RE: Hammond River Holdings' Response to Technical Review Committee (TRC)
Questions and Comments Round #2 – Proposed Upham East Gypsum Quarry, EIA
Registration Document File No. 4561-3-1508

Table 1: Summary of Responses to Round 2 TRC Questions Regarding the Proposed Upham East Gypsum Quarry, Upham, New Brunswick

CONCEPTUAL SITE LAYOUT PLAN
 FIGURE 2.3.1

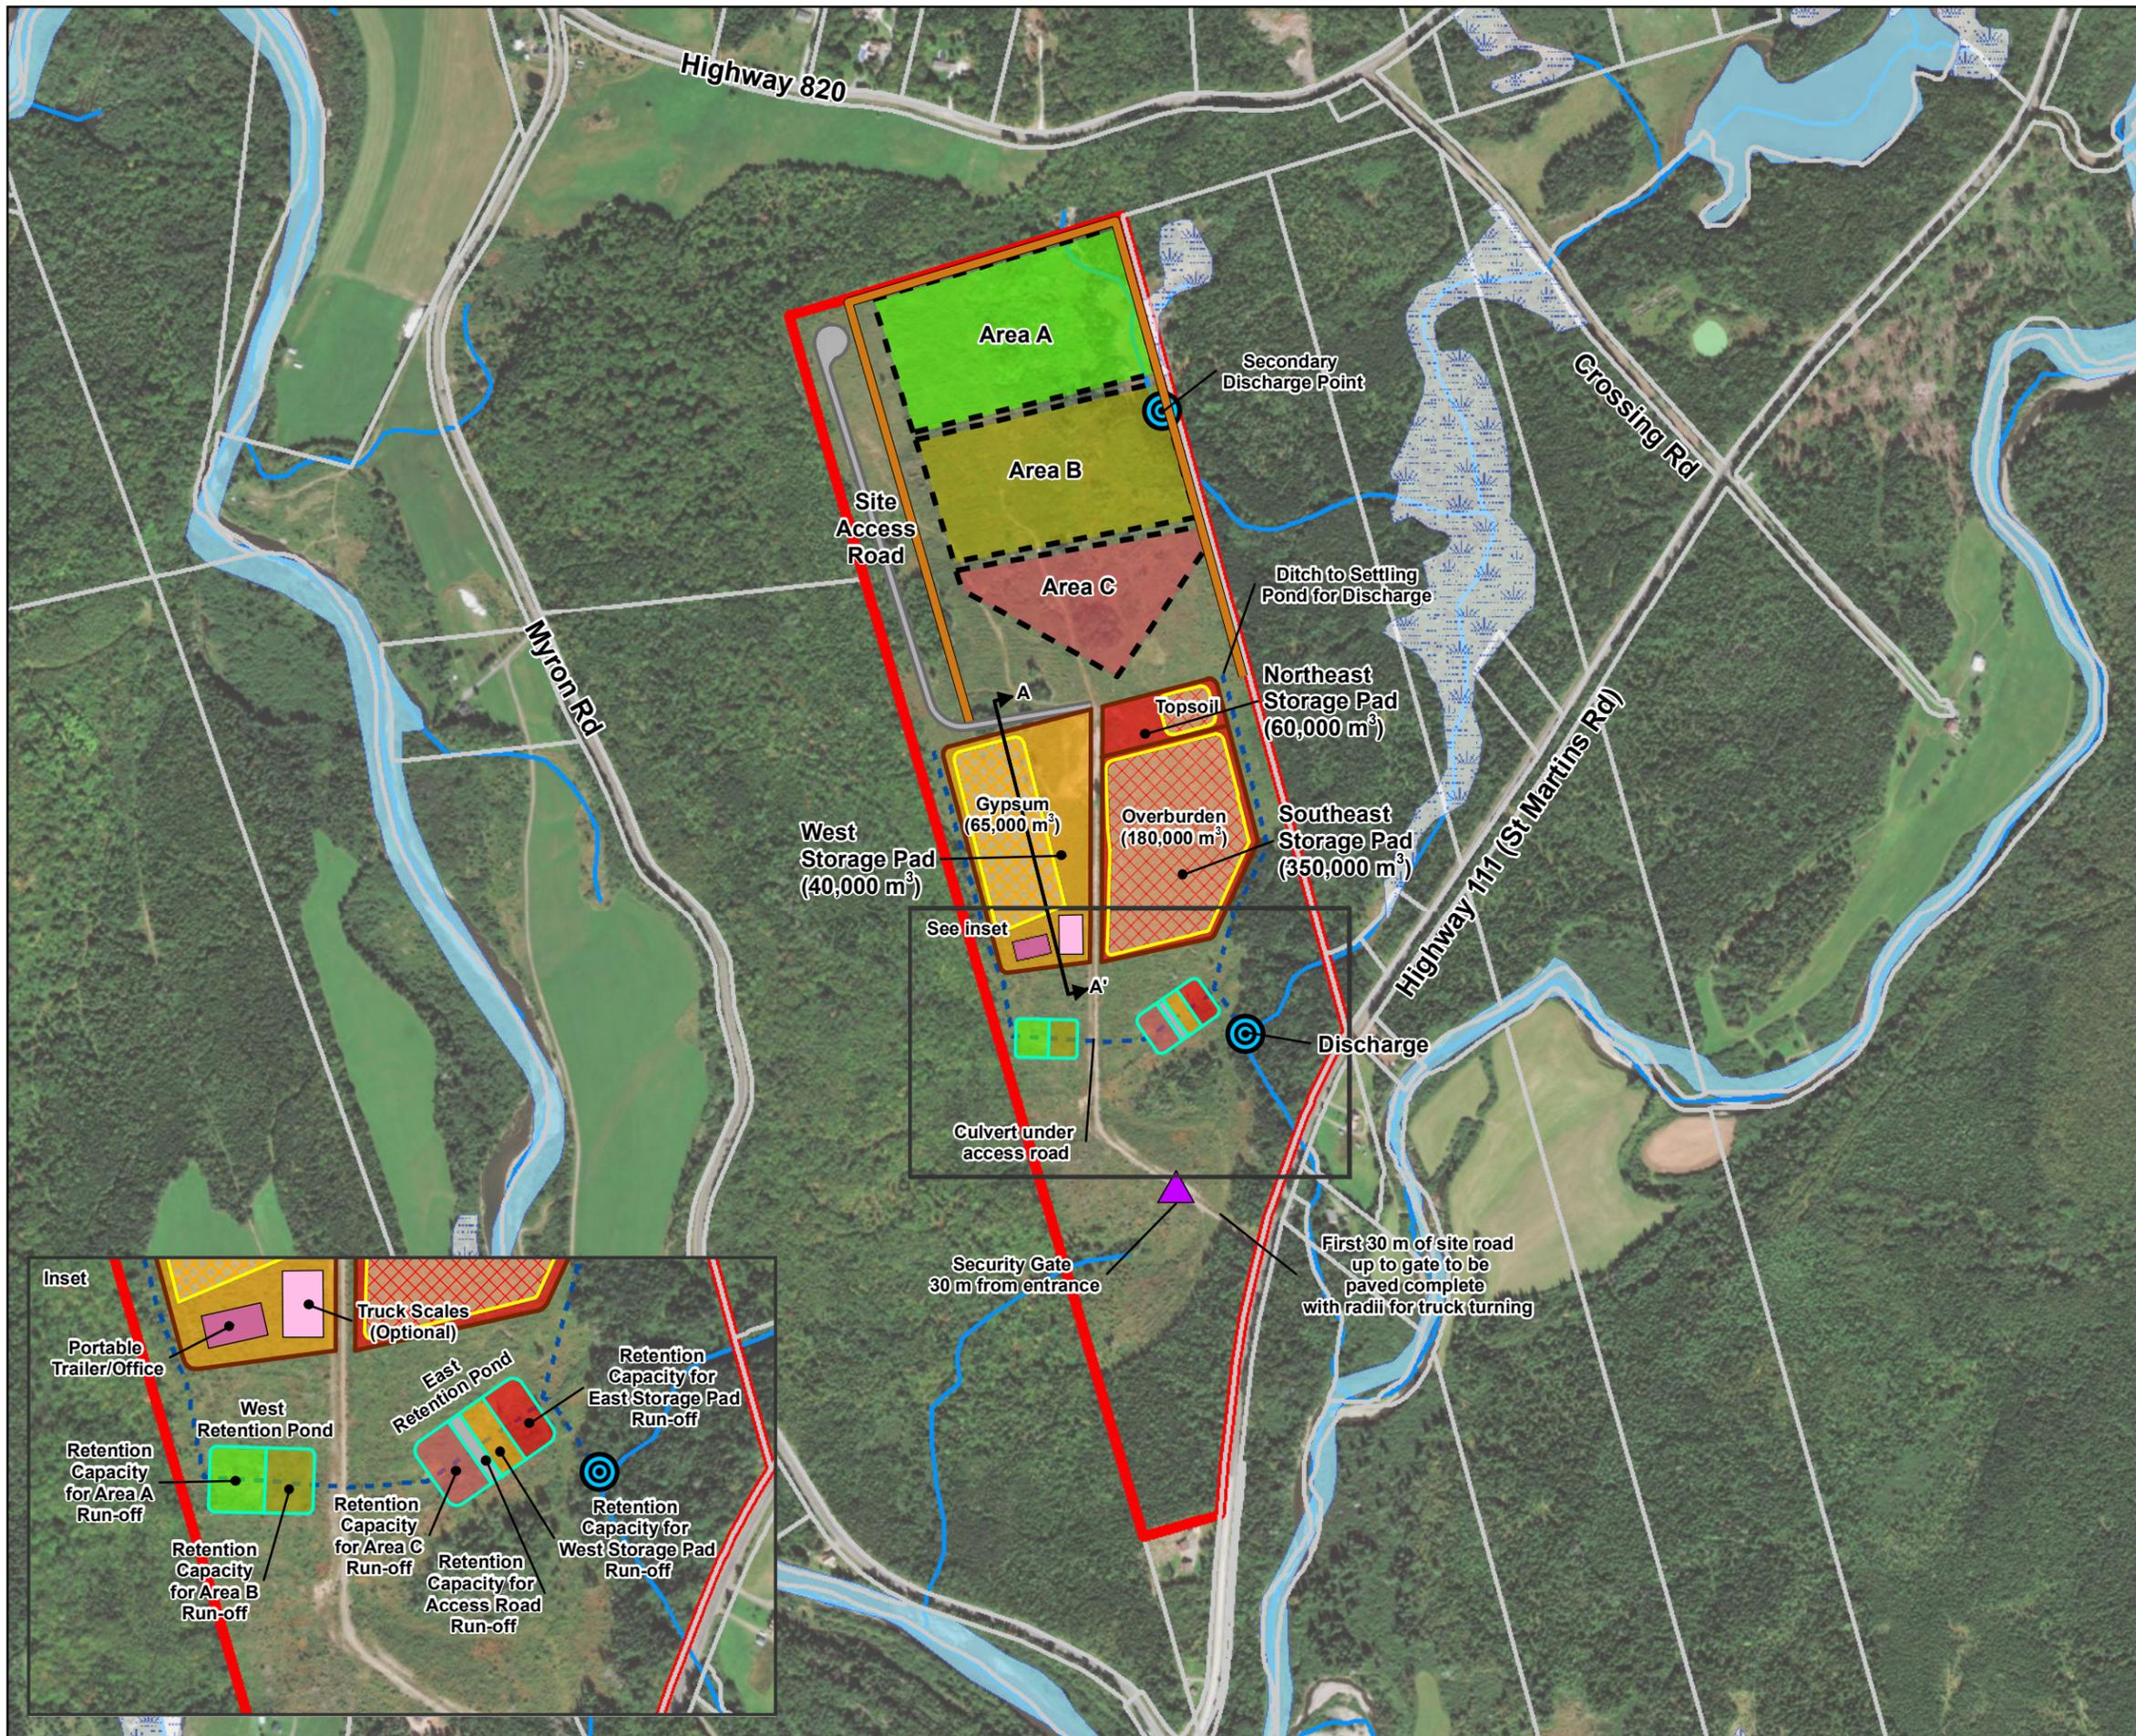
Comment/ Question No.	Question/Comment from Technical Review Committee (TRC)	Hammond River Holdings' Response
Letter Dated January 25, 2019		
Topic: Responses to TRC questions / comments (Round 1)		
3	<p>Original Round 1 Question/Comment In Figure 2.3.1 Conceptual Site Layout Plan (p. 17), can you please clarify the locations of the Gypsum Storage Area and the Topsoil and Overburden Storage Area?</p> <p>Original Response by Hammond River Holdings (Jan 4, 2019) This is a concept that will be refined during the detailed planning stage prior to the quarry becoming operational. To further elaborate on the concept, it is anticipated that the overburden will be used to level an area for the stockpiling of gypsum. Topsoil will be stockpiled separately to preserve it for future reclamation purposes. Surplus overburden materials will be used to progressively slope the final perimeter of the quarry benches to minimize re-handling of materials where appropriate. The goal will be to progressively reclaim areas of the quarry where the resource has been exhausted, while resource extraction is taking place at other areas of the quarry. The final design and management processes for the Project will be provided in the Application for an Approval to Construct for the Project.</p> <p>Response from TRC (Round 2, Jan 25, 2019) The response indicates that the requested details will be provided in the application for the Approval to Operate; however, it is felt that it's important to review this information during the EIA review process. Can you please clarify the locations of the Gypsum Storage Area and the Topsoil and Overburden Storage Area?</p>	<p>Please refer to the updated conceptual site layout plan (updated Figure 2.3.1 attached), as well as a typical cross-section that has been developed to show Project facilities in side view (with elevations).</p> <p>The following refinements to the site layout plan have been made:</p> <ol style="list-style-type: none"> 1. The quarry footprint has been reduced to reflect the current understanding of the resource geometry. Three distinct areas of the quarry (i.e., Areas A, B, and C) have been defined. A berm will be developed surrounding the quarry to provide containment for runoff and to provide some further attenuation of sound levels. 2. The storage pads have been optimized and sized based on the expected volumes of material to be handled. Three storage pads are now planned, in the same area as previously (i.e., the West storage pad storing up to 65,000 m³ of gypsum, the Northeast storage pad storing up to 60,000 m³ of topsoil and possibly other materials [e.g., dredged sediments from the retention ponds], and the Southeast storage pad storing up to 180,000 m³ of overburden). Additionally, a considerable amount of overburden will be used to develop the storage pads themselves.

Comment/ Question No.	Question/Comment from Technical Review Committee (TRC)	Hammond River Holdings' Response
		<ol style="list-style-type: none"> 3. In the quarry area, a site access road has been developed on the west side of the Project site to provide improved access to the quarry area. 4. The truck weigh scale has been moved to the north, near the West storage pad. 5. The configuration of the storage pads and stockpiles has been updated based on LiDAR, material storage and standard sloping requirements. 6. In addition to the pit sump at the bottom of the quarry (the location of which will likely change based on the work area being quarried at a given time), two retention (settling) ponds are now planned: the West retention pond (receiving runoff from Areas A and B of the quarry), and the East retention pond (receiving runoff from Area C of the quarry as well as from the access road and the West, Northeast and Southeast storage pads). The retention ponds have been repositioned and subdivided into two sub areas to improve alignment with a topographic low on the property. The West retention pond will discharge into the East retention pond, providing additional retention capacity, with both retention ponds discharging to a common location into watercourse WC3. It is noted that the pit sump will now discharge to the retention ponds instead of being pumped directly into watercourse WC1. 7. The orientation of the retention ponds has been optimized based on runoff calculations for the refined quarry footprint, storage pad areas, and LiDAR data.

Comment/ Question No.	Question/Comment from Technical Review Committee (TRC)	Hammond River Holdings' Response
		<p>8. Colour coding was added to illustrate the retention pond capacity assigned for runoff from the major components of site development (i.e., site access road, main quarry areas, and storage pads).</p>
15	<p>Original Round 1 Question/Comment Will baseline potable water supply testing include Bacteriology and turbidity? Can you please provide the baseline tests results? Will post blasting testing be completed on nearby wells? Original Response by Hammond River Holdings (Jan 4, 2019) At present, baseline well samples are proposed to be analyzed for general chemistry (including physical parameters like turbidity), bacteria, and trace metals. The baseline well sampling results will be compiled and provided to NBDELG (anonymously, to protect the privacy of the homeowners), for information purposes. Sampling of wells is currently planned to be conducted annually during operation of the project at residences within approximately 400 m of the perimeter of the Project site, but post-blasting sampling of other wells is not proposed to be conducted unless a specific concern arises with a particular well. Response from TRC (Round 2, Jan 25, 2019) The response provided indicates that the baseline groundwater well sampling results will be submitted to the DELG anonymously in order to protect the privacy of homeowners. However, all groundwater well sampling, survey data, and homeowner information should be submitted to the DELG for the file. DELG will ensure that the</p>	<p>Based on past experience, Dillon has found that some homeowners are reluctant to provide permission to sample their wells unless their information is maintained confidential, due to worries that an unfavourable well result might cause external parties to take action against them (e.g., government prohibiting them from using their well water). We have found that participation in such sampling programs tends to be greater when homeowners are given the option to remain anonymous. As such, the permission letter that Hammond River Holdings has prepared and executed (attached) gives homeowners the option for their personal information to be redacted prior submission to NBDELG. Please see attached letter template that has been prepared for residents within a 1 km radius; distribution of this letter has begun.</p> <p>If a concern arises related to a specific well, residents can either contact Hammond River Holdings or the NBDELG. In cases where the resident requested their identity be redacted, then residents will need to contact Hammond River Holdings directly, who will then notify and consult with the NBDELG. In such cases, well information would then be shared with the NBDELG if the well owner consents to such release.</p>

View A-A'
Typical Cross Section Through Overburden Storage Pad and Gypsum Stockpile

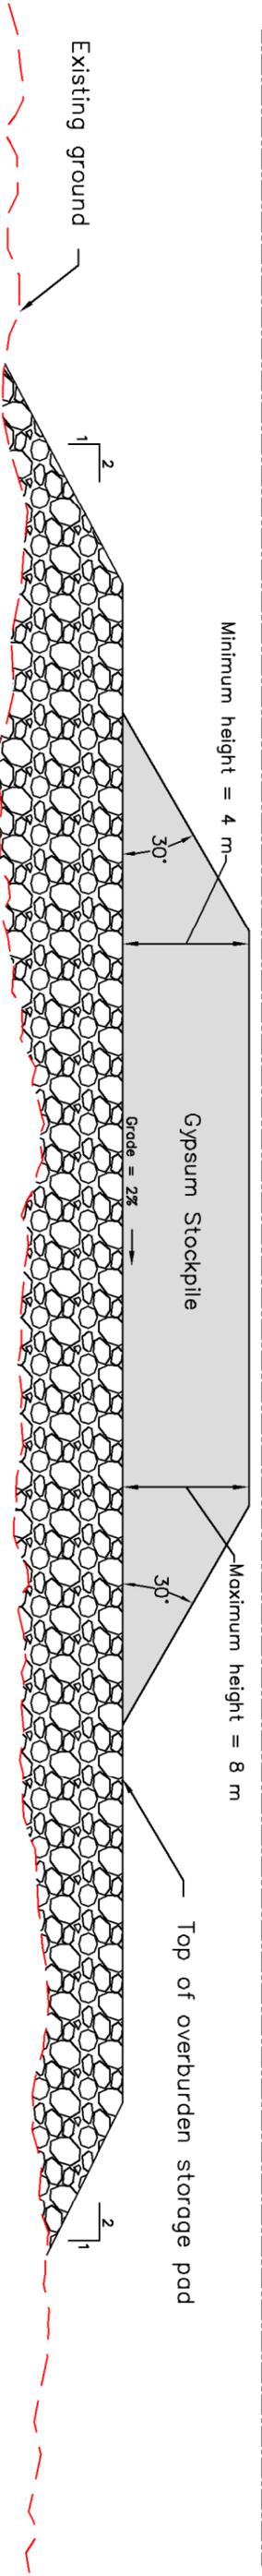
26	<p>Original Round 1 Question/Comment In Section 2.4.1.5 Removal and Stockpiling of Topsoil and Overburden (p.26), it stated that removing 10 to 15 m of overburden will entail large storage requirements for the full footprint of the quarry. What are the volume calculations for overburden storage requirements considering safe angles of the pile, safe setback from the quarry,</p>	<p>Attached is an updated conceptual site layout plan that illustrates the material management areas based on our current understanding of the geology underlying the site. Please refer to the response to question #3 above for a summary of updates to the plan. The figure also outlines the pond orientation, perimeter ditching, and berms as</p>

Comment/ Question No.	Question/Comment from Technical Review Committee (TRC)	Hammond River Holdings' Response
	<p>erosion and drainage control berms, etc.? Have those engineering calculations been made?</p> <p>Original Response by Hammond River Holdings (Jan 4, 2019) Those details will be developed as part of detailed design of the Project, prior to the Application for Approval to Operate.</p> <p>Response from TRC (Round 2, Jan 25, 2019) The response indicates that the requested details will be provided in the application for the Approval to Operate; however, it is felt that it's important to review this information during the EIA review process. Can you please provide clarification regarding the volume calculations for overburden storage requirements considering safe angles of the pile, safe setback from the quarry, erosion and drainage control berms? Have those engineering calculations been made?</p>	<p>we currently understand them. This plan may be further optimized as site development proceeds.</p> <p>The overall plan was developed based on the following considerations:</p> <ul style="list-style-type: none"> • The current topographic high point on the property is approximately 105 m elevation above sea level based in the same vertical datum employed by GeoNB (CGVD 1928) . For the purposes of material management planning, this elevation was adopted as the maximum elevation for all material stockpiles. • The storage pads will be sloped at 2:1, stockpiles will be sloped at 1.7:1 • Storage pads will be constructed using overburden stripped from quarry areas. • Initially, stripped topsoil and overburden will be used to construct a safety berm at a minimum of 7 m back from the edge of the quarry perimeter. Surplus topsoil left over after berm construction will be stockpiled on the Northeast storage pad. • For the purposes of stockpiling surplus topsoil, the Northeast storage pad will be constructed first, ranging in approximate elevation from 100 to 103 m. • To facilitate the storage of gypsum, it is anticipated that the West storage pad will then be constructed, ranging in approximate elevation from 96 m to 103 m.

Comment/ Question No.	Question/Comment from Technical Review Committee (TRC)	Hammond River Holdings' Response
		<ul style="list-style-type: none"> • For stockpiling of surplus overburden, the Southeast storage pad will be constructed last, ranging in elevation from 81 m to 100 m. • Based on the available borehole information, the total approximate volume of overburden and topsoil to be removed from the quarry footprint is 1,200,000 m³. (Note that since the quarry will be developed in stages, not all this material will be removed at once, or require storage at any given time). Of this total approximate volume, 450,000 m³ will be used to construct the storage pads for the entirety of the project. Another 180,000 m³ will be piled on the pads at various times throughout the operation. The remaining 570,000 m³ of stripped overburden and topsoil from the quarry footprint will be used to progressively reclaim the quarry until the gypsum resource is exhausted. • The runoff from the material management areas will be directed to the perimeter ditches and in turn to the retention ponds. Refer to inset on the figure for additional details concerning the retention ponds. • Where appropriate, Hammond River Holdings will adopt standard erosion and sediment control practices as outlined in New Brunswick Department of Transportation and Infrastructure's Standard Specifications for Highway Construction and Environment Management Manual https://www2.Environment Management Manual.ca/content/dam/gnb/Departments/trans/pdf/en/RoadsHighways/EnvironmentalManagementManual.pdf.

Comment/ Question No.	Question/Comment from Technical Review Committee (TRC)	Hammond River Holdings' Response
		<p>The NBDTI Environmental Management Manual (2010) recommends 190 m³ of retention capacity per hectare (ha) of disturbed area. The retention ponds, as identified on the updated site layout plan, provide for a retention ratio of 250 m³/ha.</p> <p>The construction of the retention ponds will be sequenced to maintain a retention ratio of 250 m³/ha of exposed area as site development progresses. As the extraction of gypsum progresses there will be additional retention capacity in the quarry that, if necessary, can contribute to a 250 m³/ha retention ratio by means of reducing the pumping rate to the retention ponds from the quarry during extreme weather events.</p>
27	<p>Original Round 1 Question/Comment In Section 2.3.4 Topsoil and Overburden Storage Area (p. 19), based on information available to date, what are the expected dimensions of the topsoil and overburden storage areas and how high are the piles expected to be?</p> <p>Original Response by Hammond River Holdings (Jan 4, 2019) Those details will be developed as part of detailed design of the Project, prior to the Application for Approval to Operate.</p> <p>Response from TRC (Round 2, Jan 25, 2019) The response indicates that the requested details will be provided in the application for the Approval to Operate; however, it is felt that it's important to review this information during the EIA review</p>	<p>Refer to the responses to Questions 3 and 26, above. Additional information can be found in the cross-sections.</p>
